UNITED STATES PATENT AND TRADEMARK OFFICE

APPLICATION NO.	FILING DATE	FIRST NAMED INVENTOR	ATTORNEY DOCKET NO.	CONFIRMATION NO.
10/603,450	06/24/2003	Ernest B. Pryor JR.	10499-649US (795210104-03)	4405
570	7590	08/10/2005	EXAMINER	
AKIN GUMP STRAUSS HAUER & FELD L.L.P. ONE COMMERCE SQUARE 2005 MARKET STREET, SUITE 2200 PHILADELPHIA, PA 19103			SOOHOO, TONY GLEN	
			ART UNIT	PAPER NUMBER
			1723

Office Action Summary

DETAILED ACTION

FIG. 3

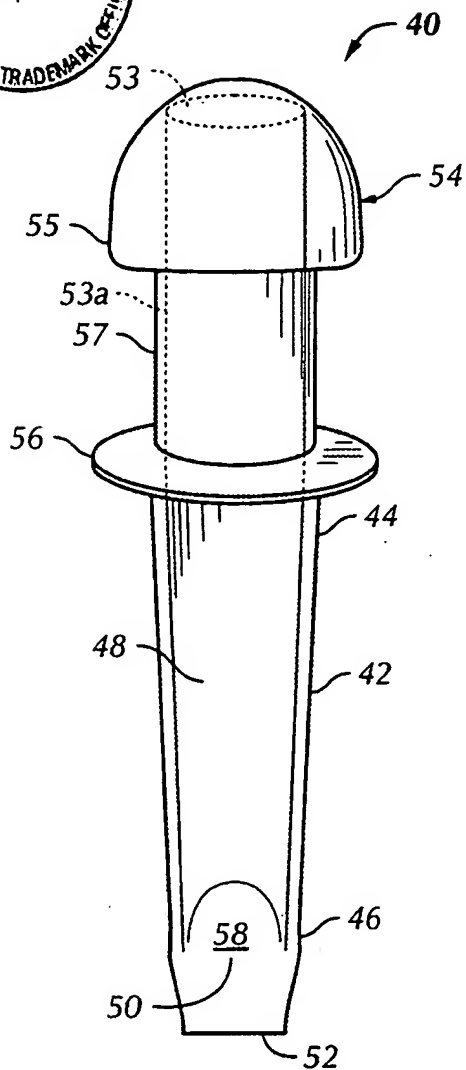
1. The drawings were received on 5-19-2005. These drawings are NOT APPROVED. The drawings introduce new matter to the showing of the relative position of the handle opening through the handle itself, in a longitudinal manner along the handle and upon both element of figures the embodiments of fig 3 and fig 6. Basis is only for the handle having an opening in communication with the cavity, but falls short of a enablement of the opening through the handle itself.

Not
Approved
TGS 8-8-05
TONY G. SOOHOO
PRIMARY EXAMINER

Applicant is required to cancel the new matter in the reply to this Office Action.

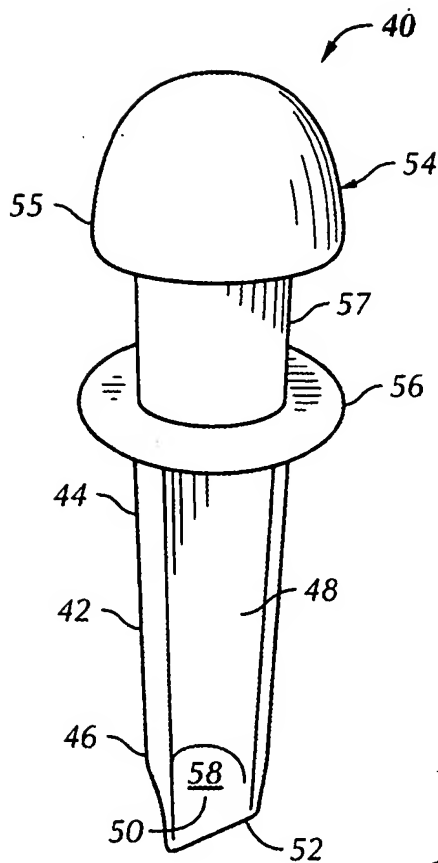
NOT
APPROVED
TO
8-8-05
